ZRD1: Zoning Resolution Determination Form

The above referenced address is the lead address for a proposed development of 38 townhouses developed on a single zoning lot. The zoning lot is located in the Special Long Island City District and is zoned M1-4/R6A. Each townhouse will be an R-3 occupancy two-unit structure, will sit on its own tax lot and will obtain its own Certificate of Occupancy. All applications will be filed to comply with the 2014 NYC Building Code.

ZRD1/CCD1 Response Form

PROJECT:
L.I.C. Two Family Dwellings - 46th Avenue Entry Stairs

SITE PLAN

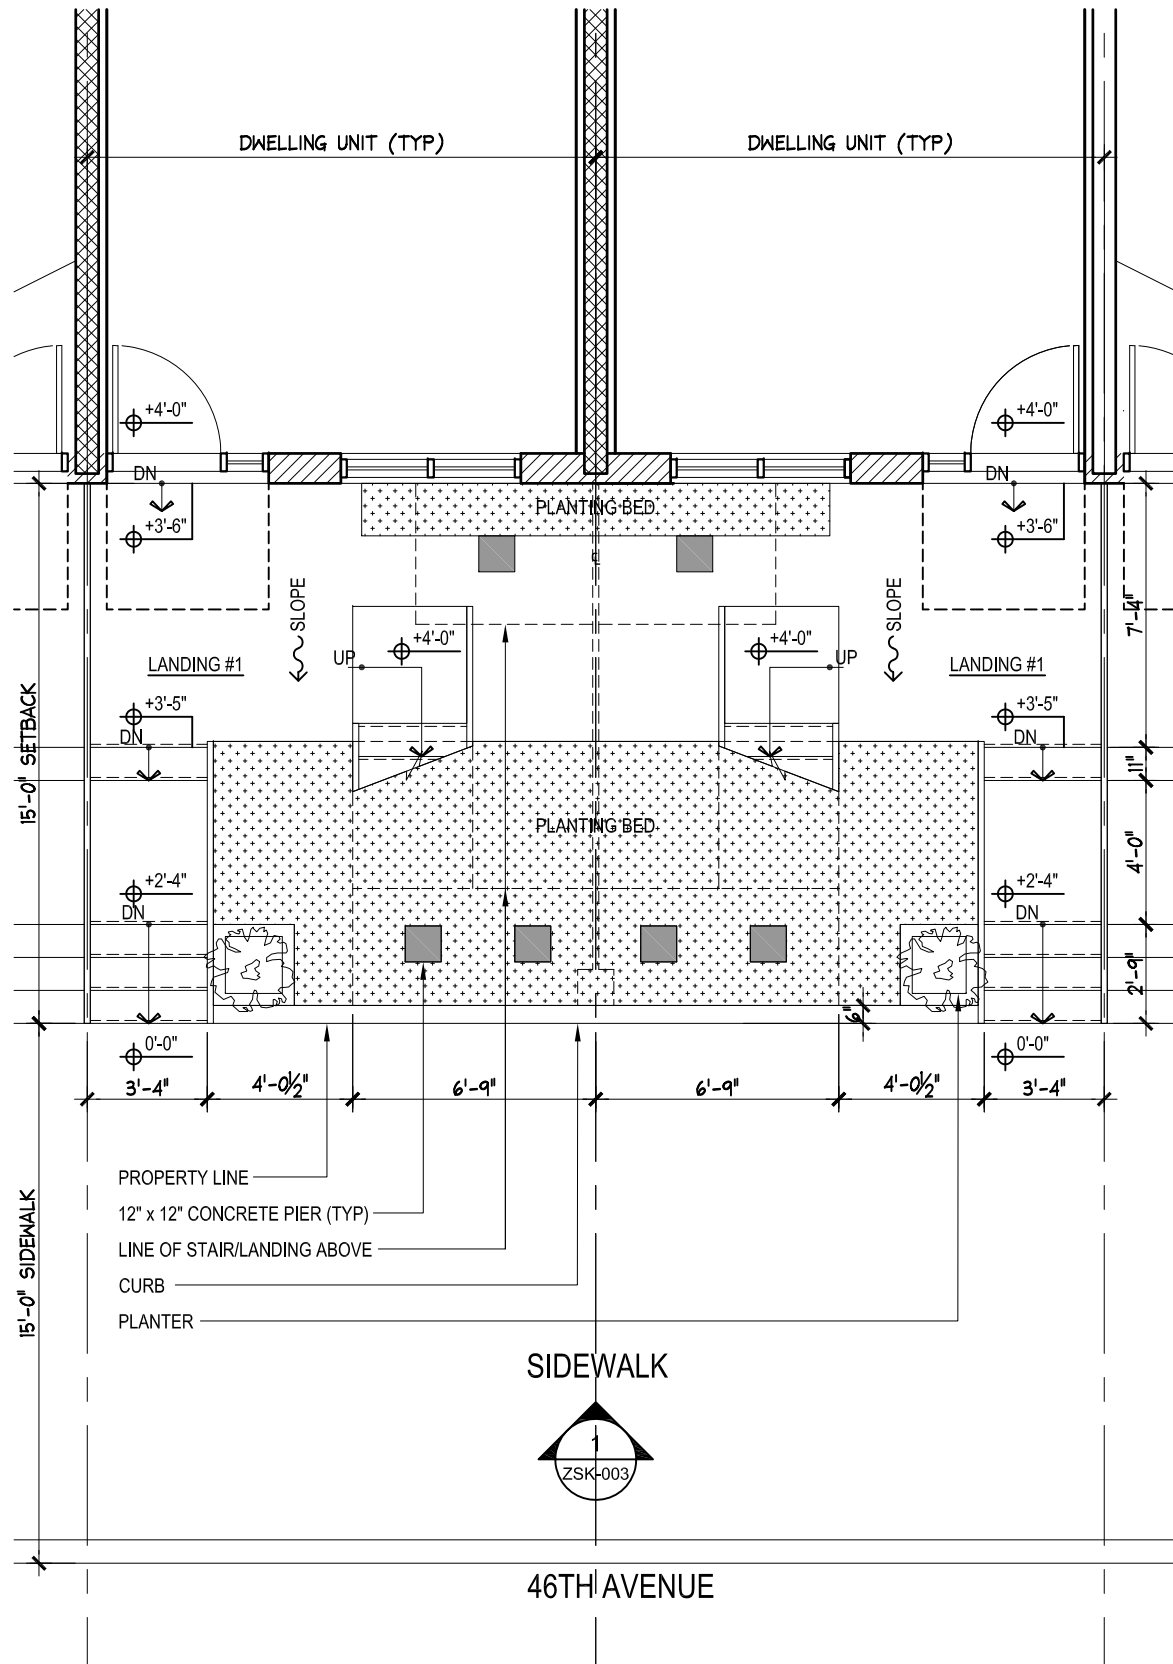
Provide location on site plan

Clarify Side Yard at Lot 131

Clarify: Provide applicable Lot number(s)

46TH STREET - PARTIAL AXONOMETRIC VIEW

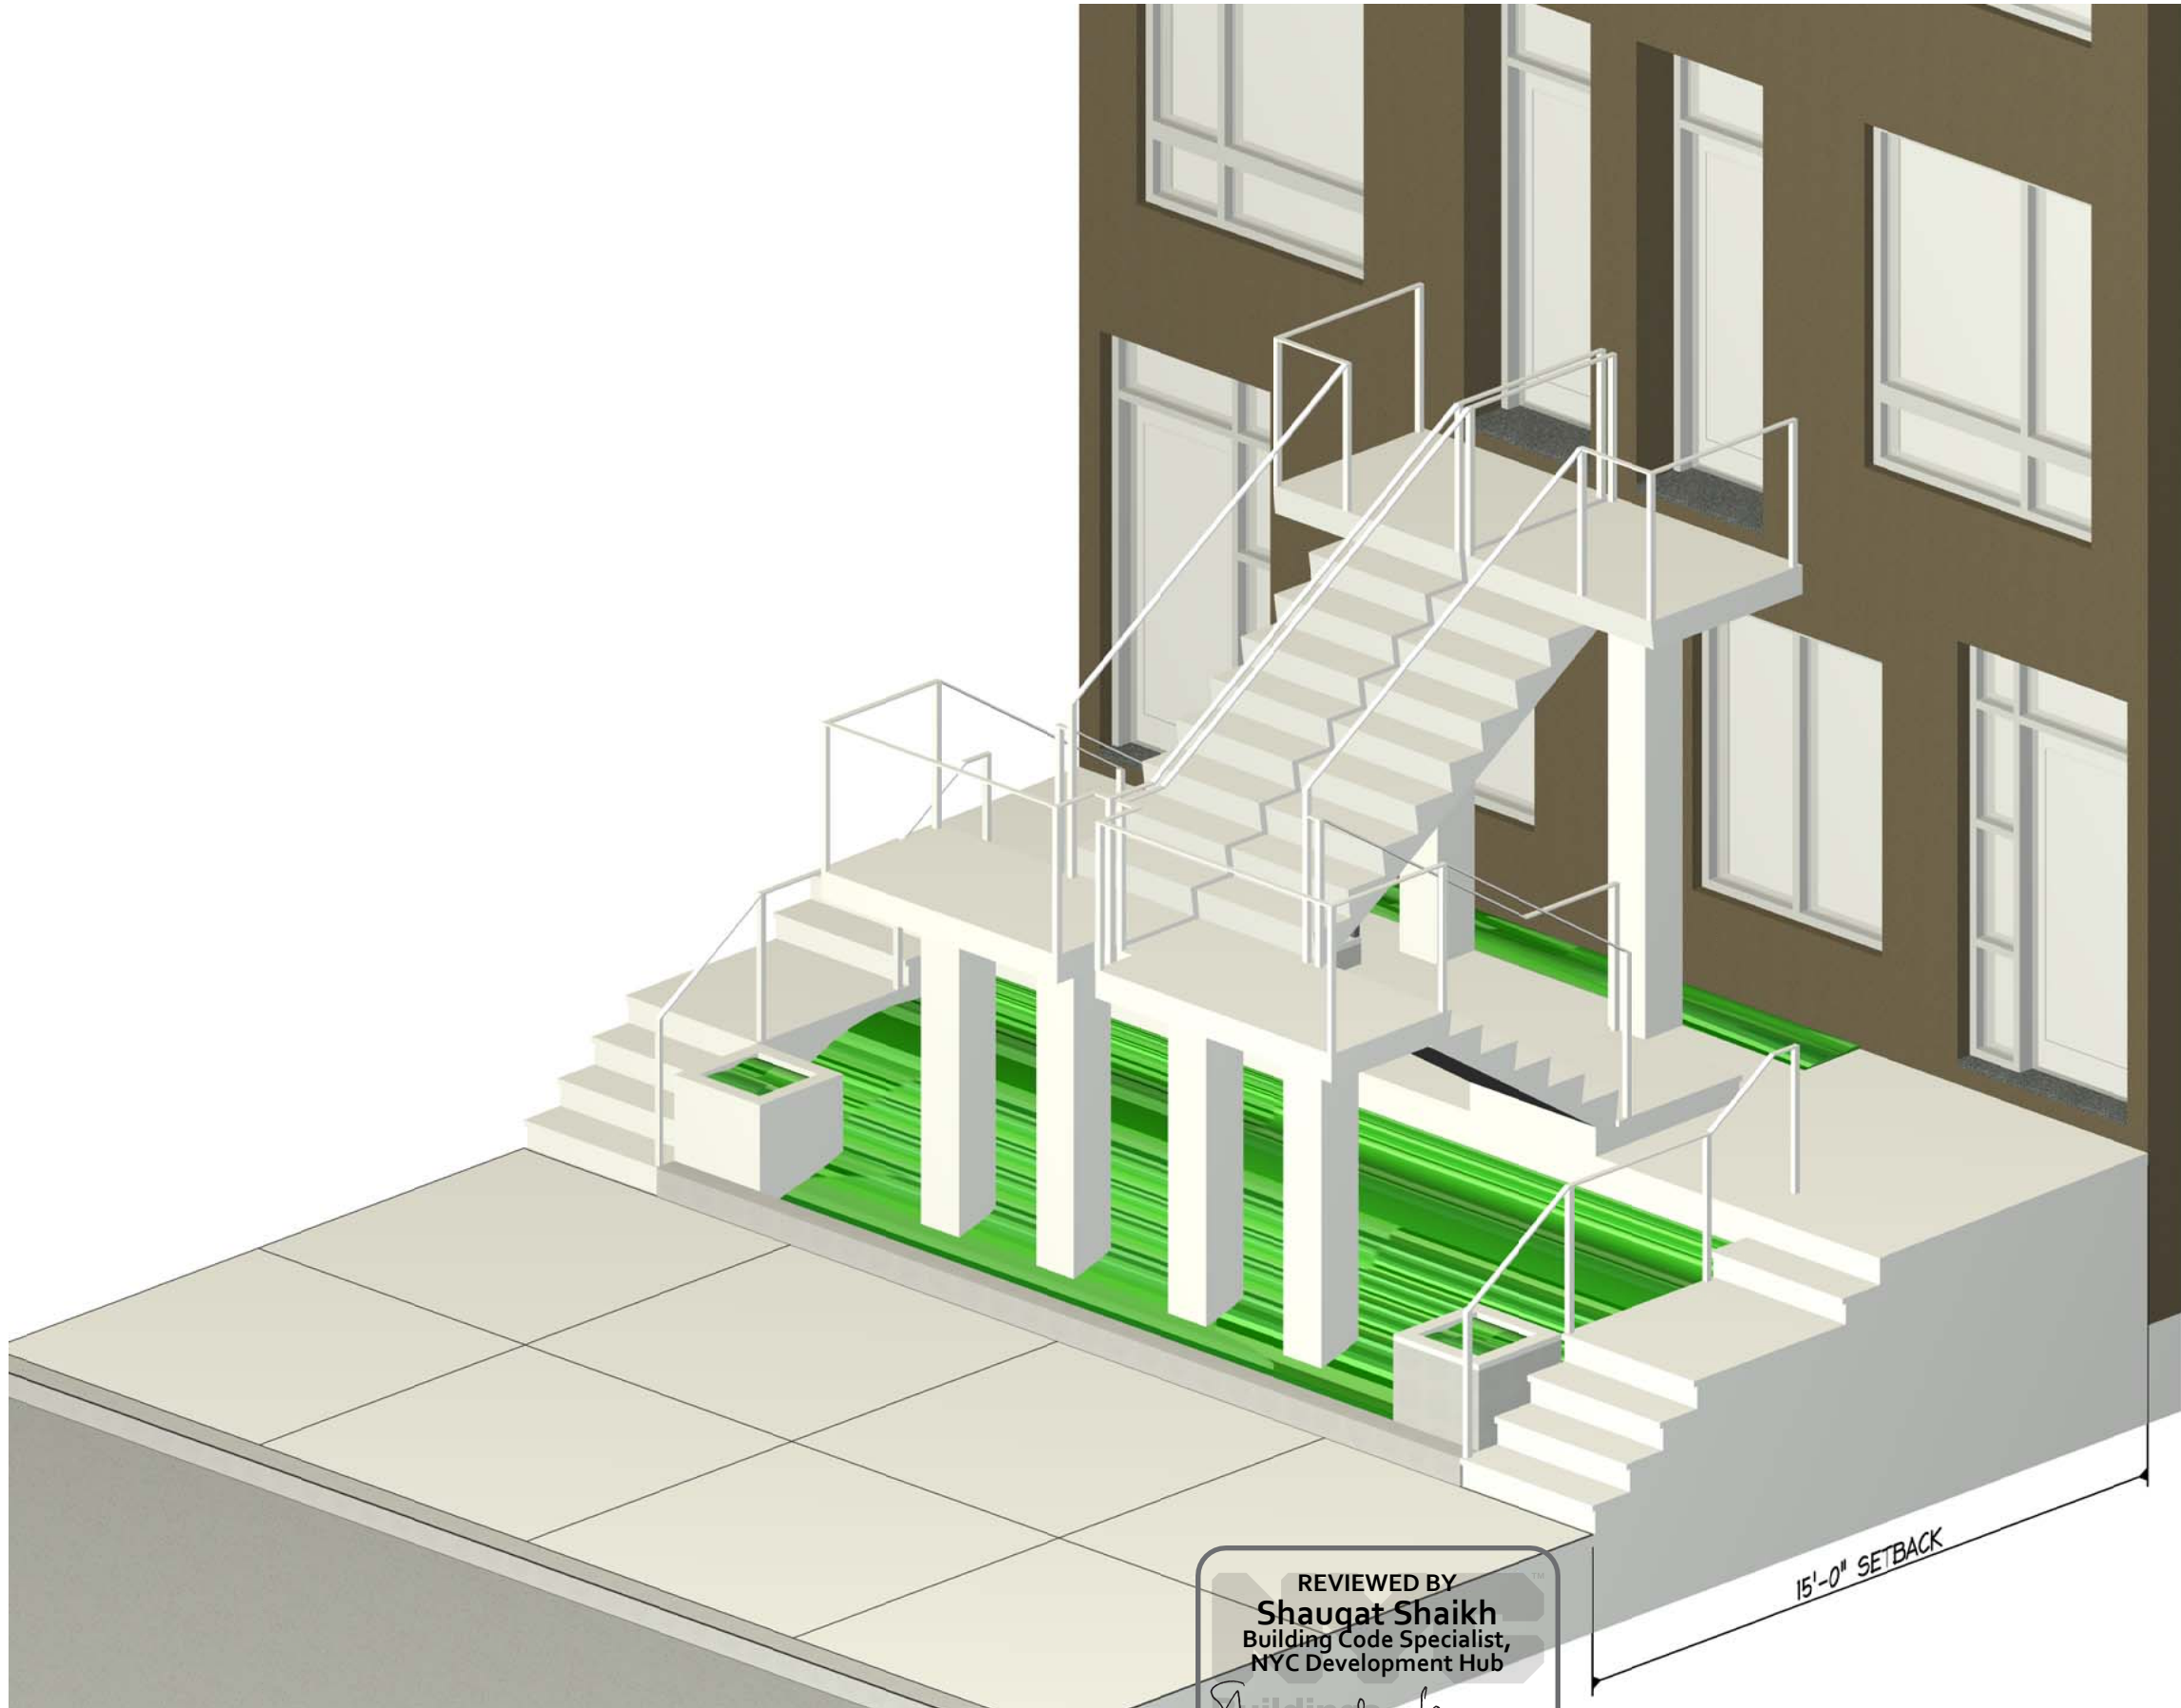
ZR23-44: stairs are not permitted in the front yard.

ZR23-12: Stairs are not permitted in required open space.

TPPN 26/70: Stairs are not permitted to access the second floor of a more than 3 story building.

The request to wave the comments (objections) for the proposed open stairs is hereby approved with the conditions that these stairs are include as lot coverage in the zoning analysis.

The proposed stairs are located in the open area which is neither required front yard nor required open space hence the compliance with ZR 23-44 (also TPPN 4/200) and ZR 23-12 are not applicable.
